## **ADDENDUM NO 1**

TO: All Prospective Bidders  
DATE: April 4, 2017  
PROJECT: Pedestrian Sidewalk Improvements at Entry 4 (WP-16-13-99)  
Recreation Center Exterior Entrance Improvements (WP-16-16-29)

CADD FILE: 16-119-CP(BE) SHEET 3 OF 14

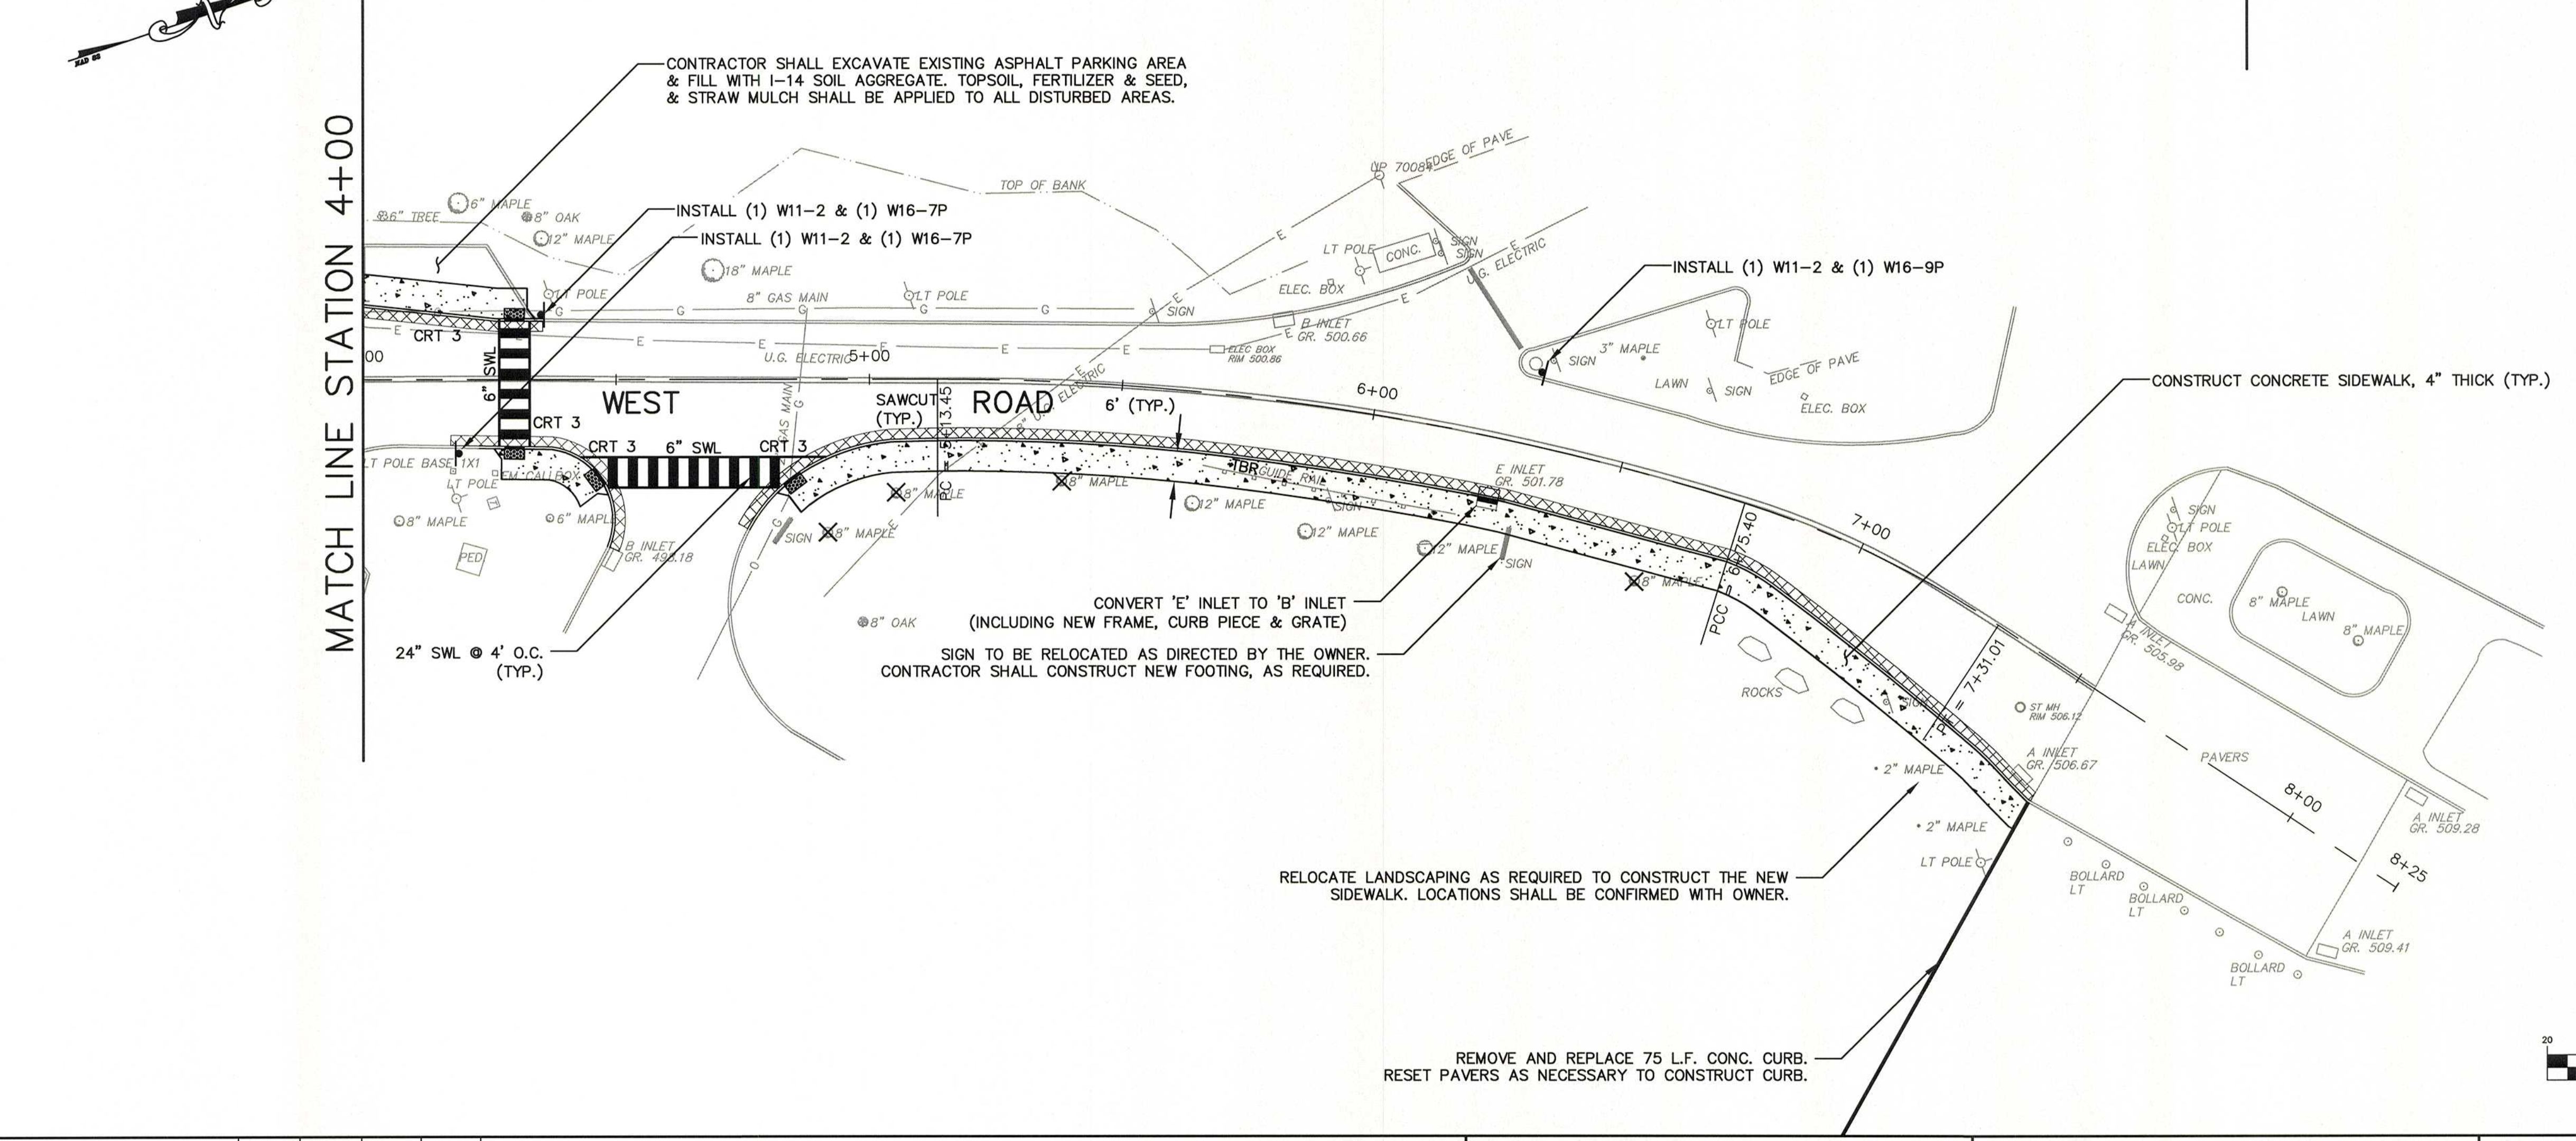
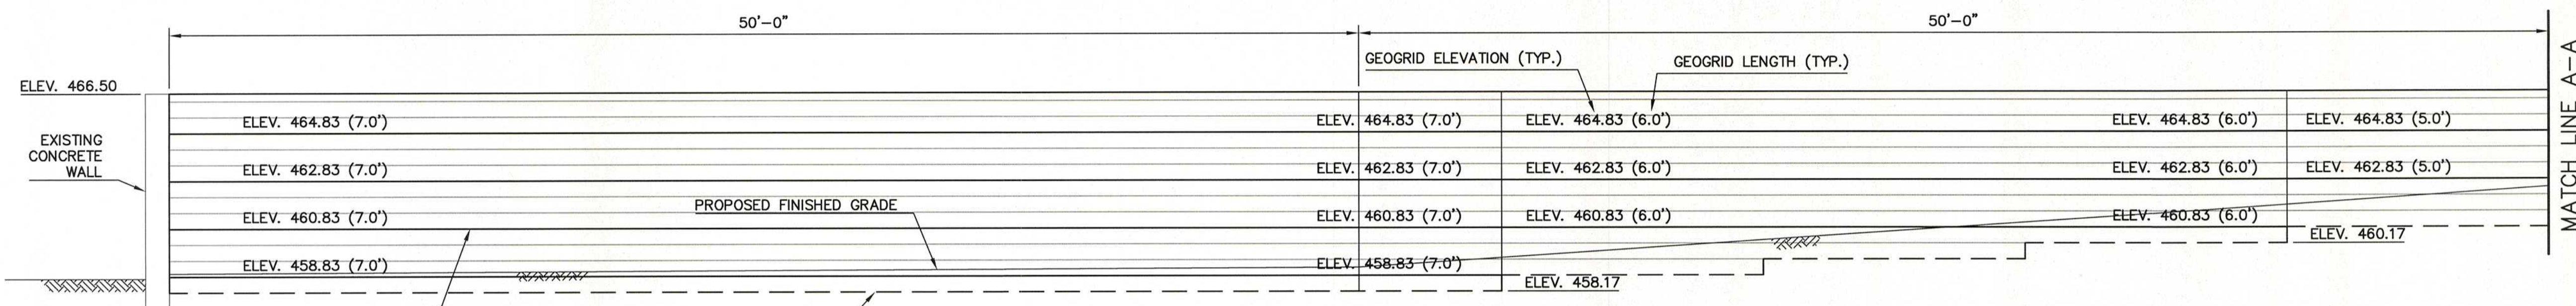
**Note: Addition of 40 LF 6" SWL traffic marking as shown in Sheet 3 of 14.**

CADD FILE: 16-119-ST (E) SHEET 7 OF 14

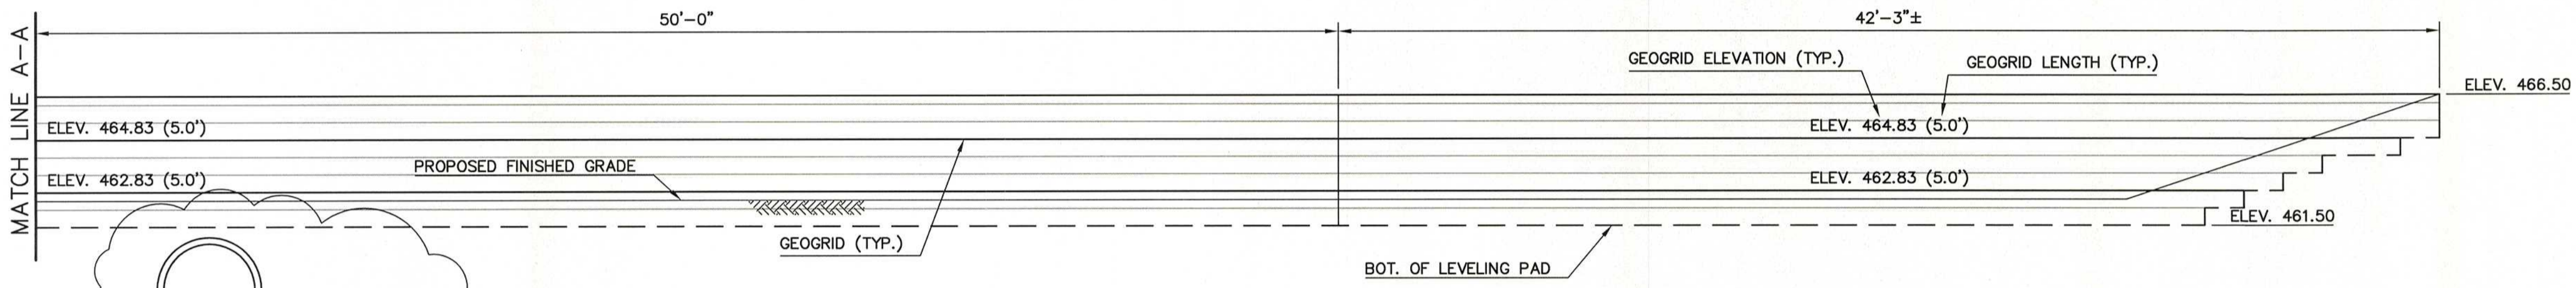
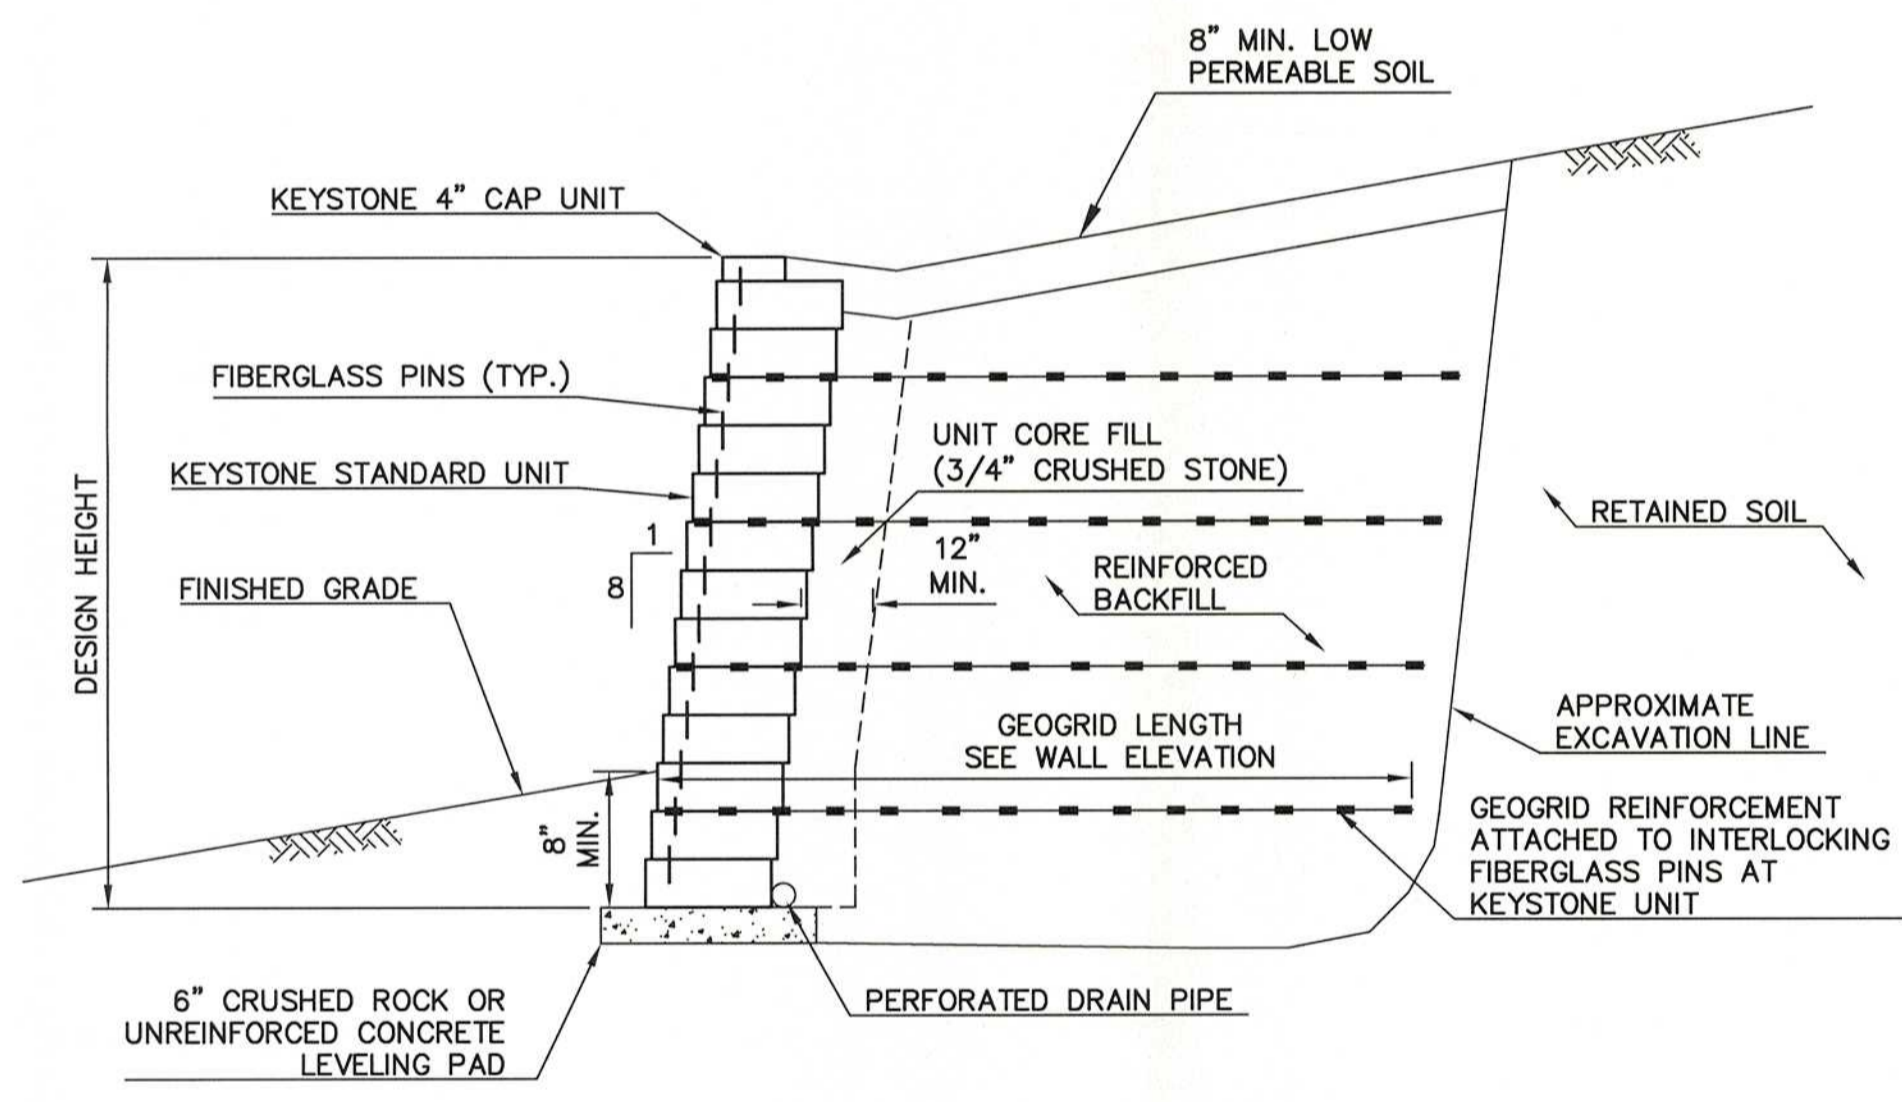
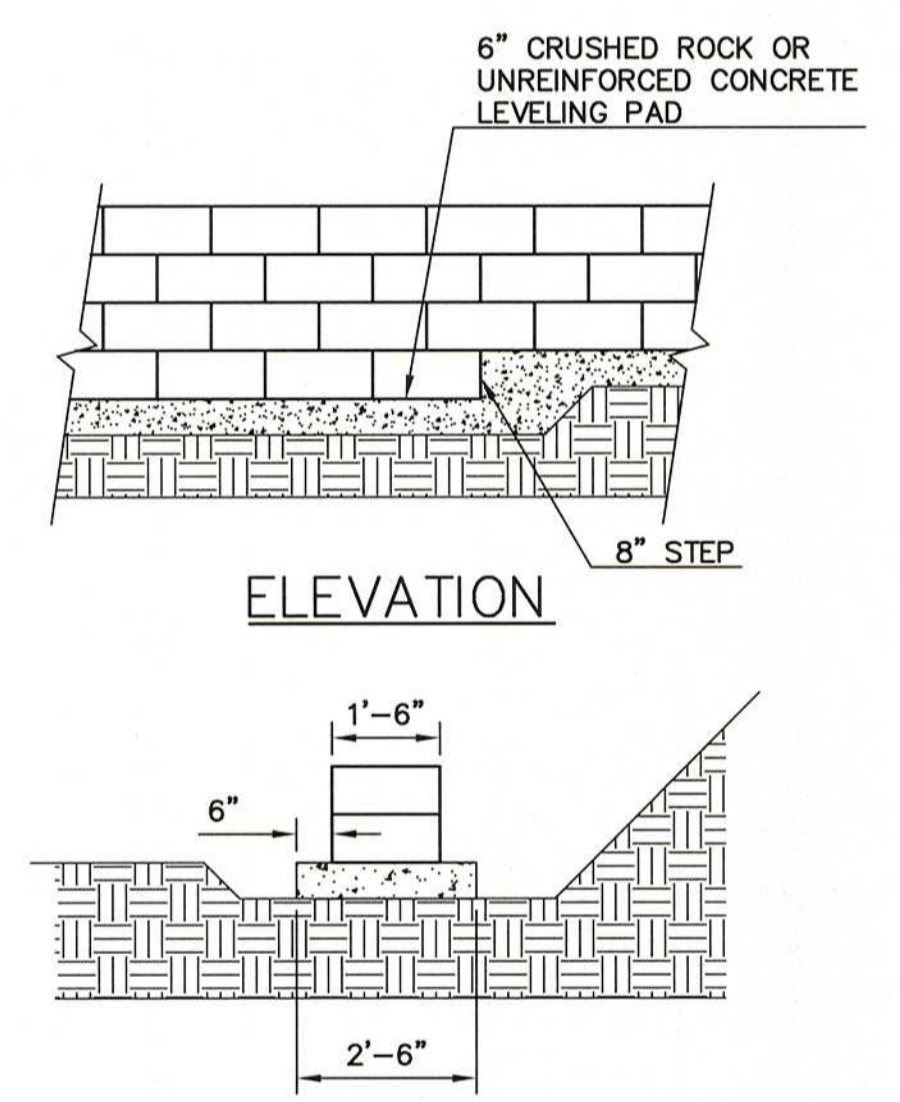
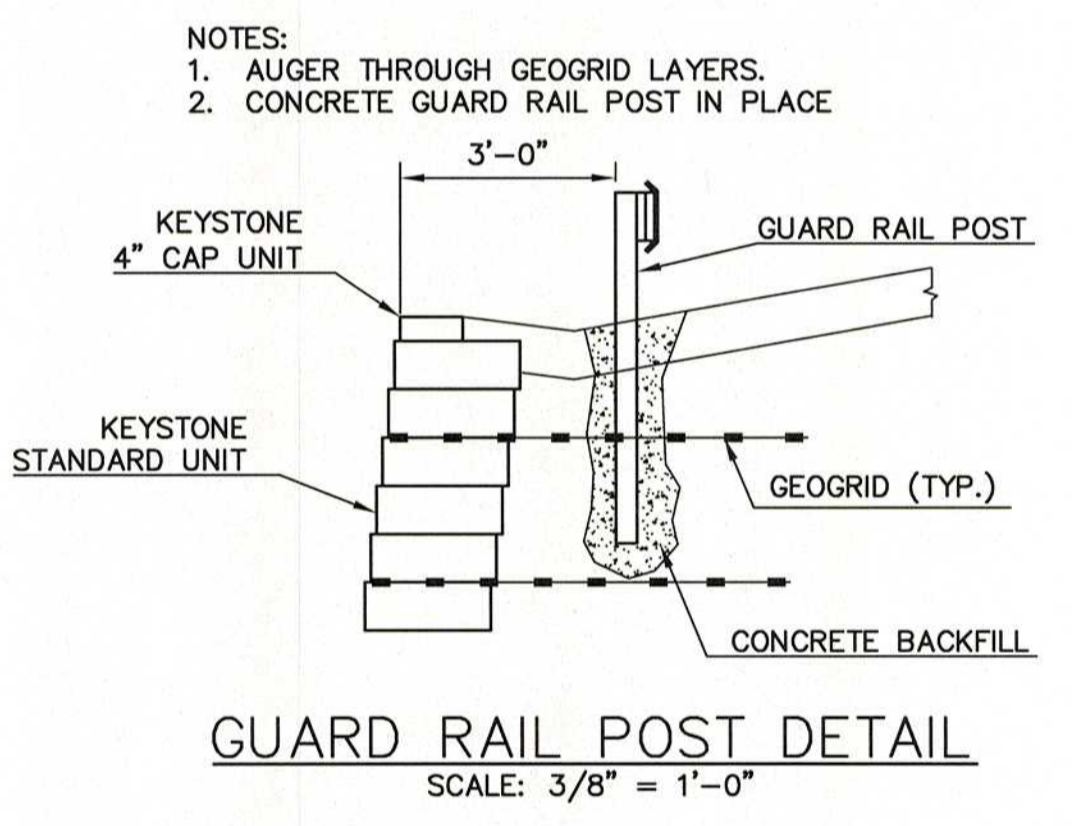
Q. Sheet 7 of 14 and sheet 5 of 14: Drawing 7 shows large RCP pipe as 48", drawing 5 shows pipe as 42", which diameter is correct?

**A. 42" RCP is correct. Attached please find revised Plan Sheet 7.**

EVERGREEN TREE PLANTING DETAIL  
N.T.S.

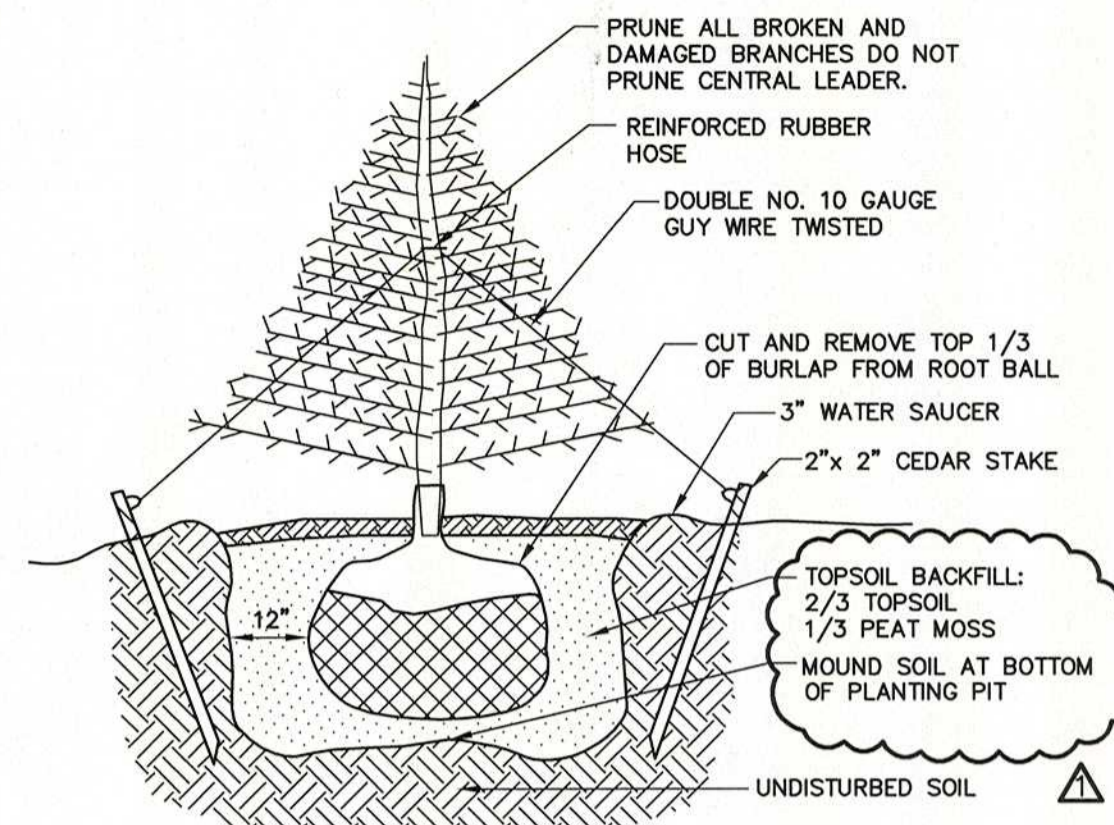
Q. Sheet 14 of 14: Detail "EVERGREEN PLANTING DETAIL" shows 1/3 of a material at bottom of planting pit, please clarify what material that is.

**A. Material is 2/3 topsoil, 1/3 peat moss. Attached please find revised Plan Sheet 14.**
